Well Name: TOP SPOT 12_13 FEDERAL COM	Well Location: T22S / R31E / SEC 13 / SESW / 32.385551 / -103.732419	County or Parish/State: EDDY / NM
Well Number: 22H	Type of Well: OIL WELL	Allottee or Tribe Name:
Lease Number: NMNM29233	Unit or CA Name:	Unit or CA Number:
US Well Number: 3001547889	Operator: OXY USA INCORPORATED

Type of Submission: Notice of Intent

Type of Action: APD Change

Procedure Description: Oxy USA Inc., respectfully requests to amend the subject APD with the following updates: UPDATED 4S FALCON PLAN - THE WELL NAME, SHL, BHL, HSU SIZE, TVD, SURFACE CASING, INTERMEDIATE CASING, AND PRODUCTION CASING ARE CHANGING. The C-102, DRILL PLAN, CASING CONNECTIONS AND DIRECTIONAL PLAN ARE ATTACHED. UPDATED VARIANCE REQUESTS FOR BOP BREAK TESTING, BRADENHEAD CBL, AND OFFLINE CEMENT ARE ATTACHED. "SHL MOVING BY 18 FEET TO THE SOUTH AND 45 FEET TO THE EAST. THERE IS NO ADDITIONAL SURFACE DISTURBANCE RELATED TO THIS SUNDRY"

OXY APD CHANGE SUNDRY LIST

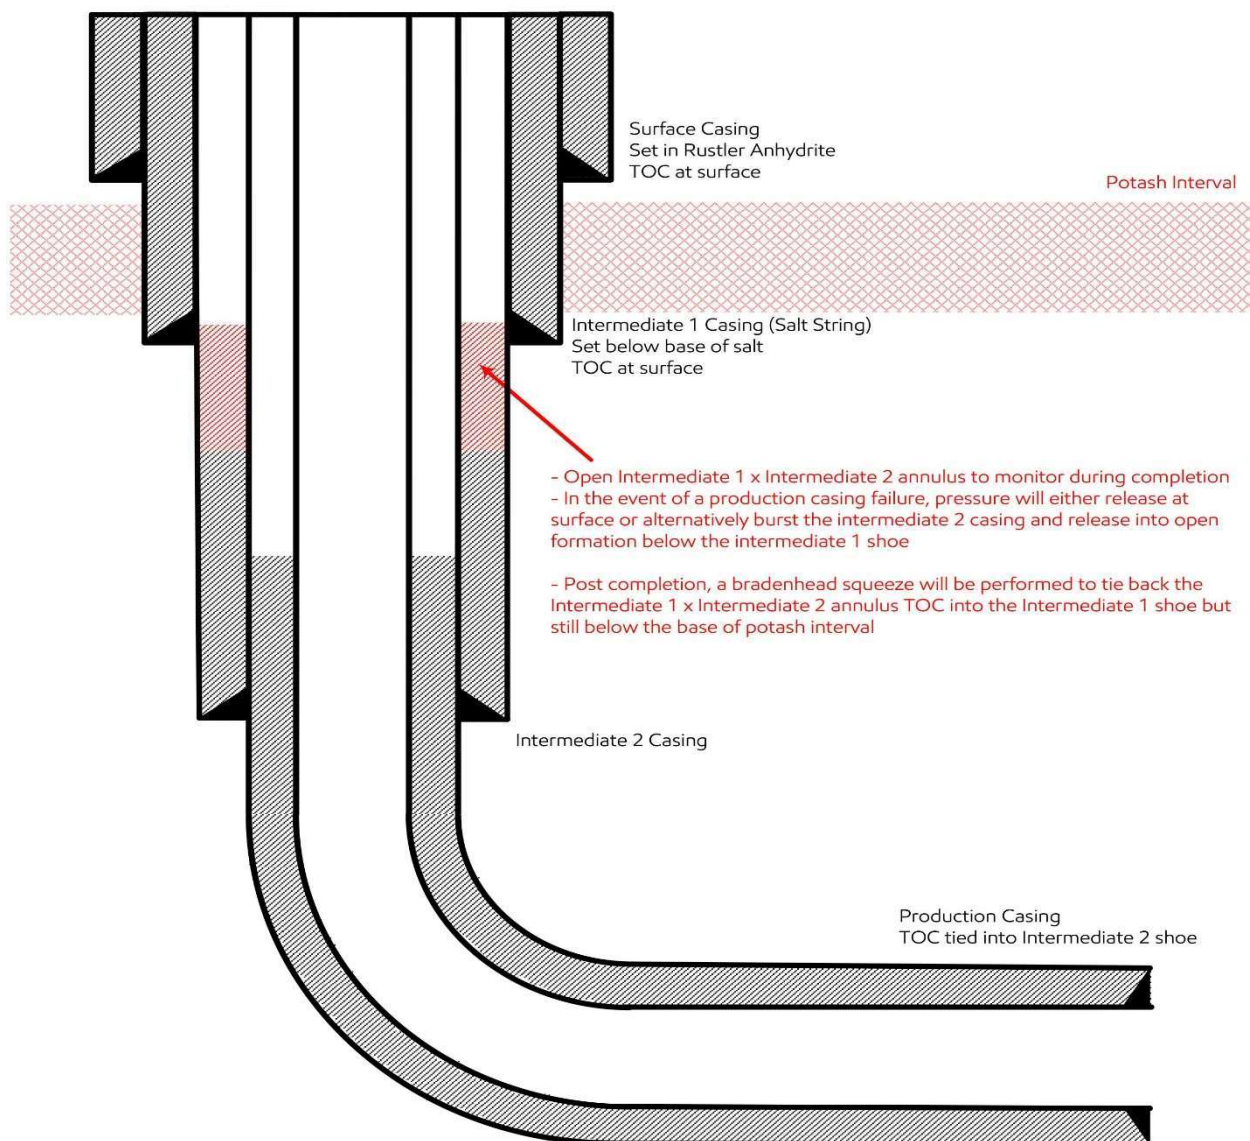
- 1) Alignment with KPLA requirements per schematic above, leaving open annulus for pressure monitoring during frac and utilizing new casing that meets API standards
- 2) Contingency plans in place to divert formation fluids away from salt interval in event of production casing failure
- 3) Bradenhead squeeze to be completed within 180days to tie back TOC to salt string at least 500ft but with top below Marker Bed 126
- 4) Production cement to be tied back no less than 500ft inside previous casing shoe

3-String Design – Open Production Casing Annulus

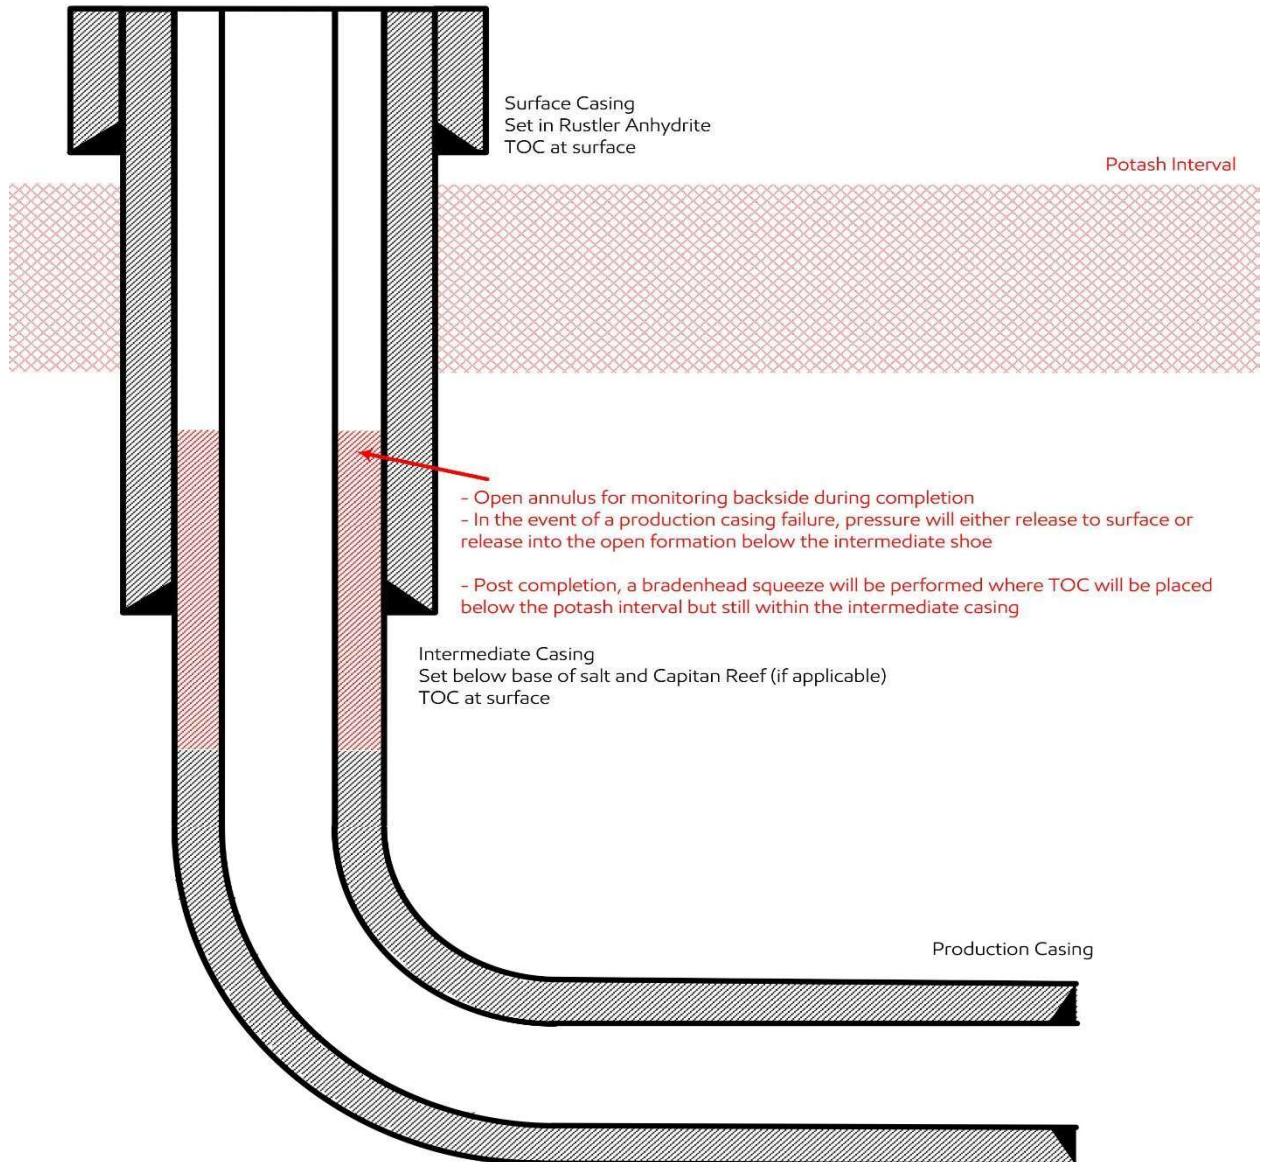
Update May 2024:

- 1) Alignment with KPLA requirements per schematic above, leaving open annulus for pressure monitoring during frac and utilizing new casing that meets API standards
- 2) Contingency plans in place to divert formation fluids away from salt interval in event of production casing failure
- 3) Bradenhead squeeze for Production cement to be completed within 180 days to tie back TOC to previous casing string at least 500ft but with top below Marker Bed 126

Form C-102
Revised August 1, 2011
Submit one copy to appropriate
District Office

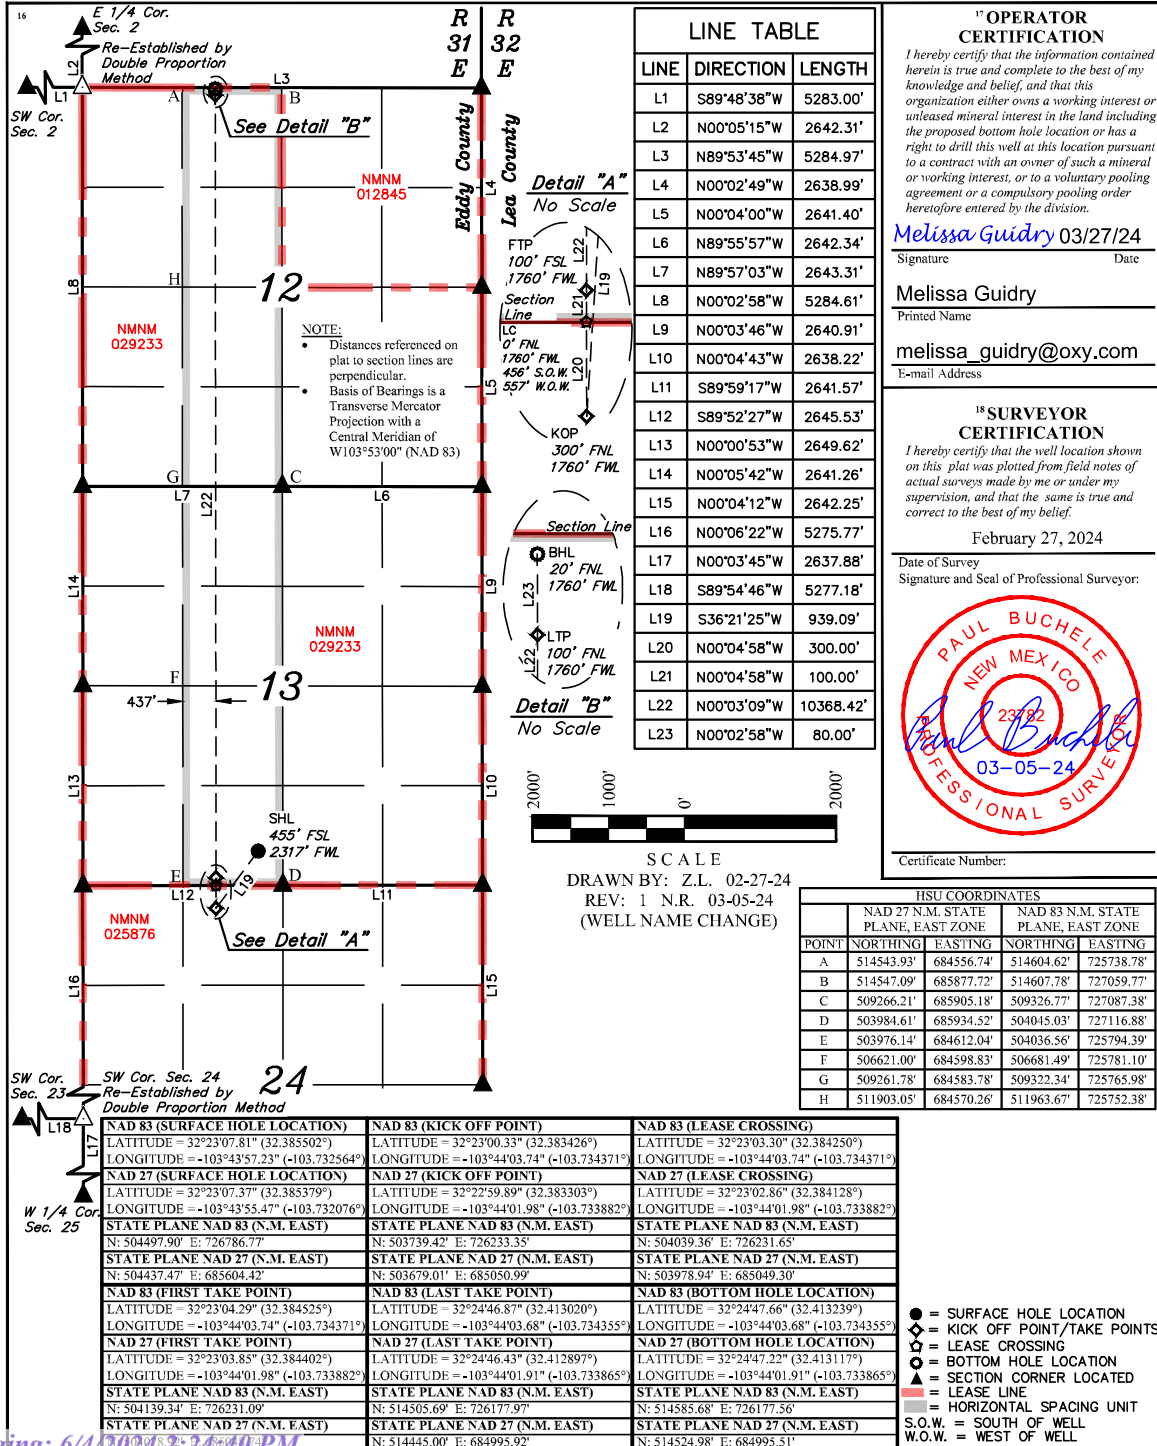
"SHL MOVING BY 18 FEET TO THE SOUTH AND 45 FEET TO THE EAST. THERE IS NO ADDITIONAL SURFACE DISTURBANCE RELATED TO THIS SUNDRY"
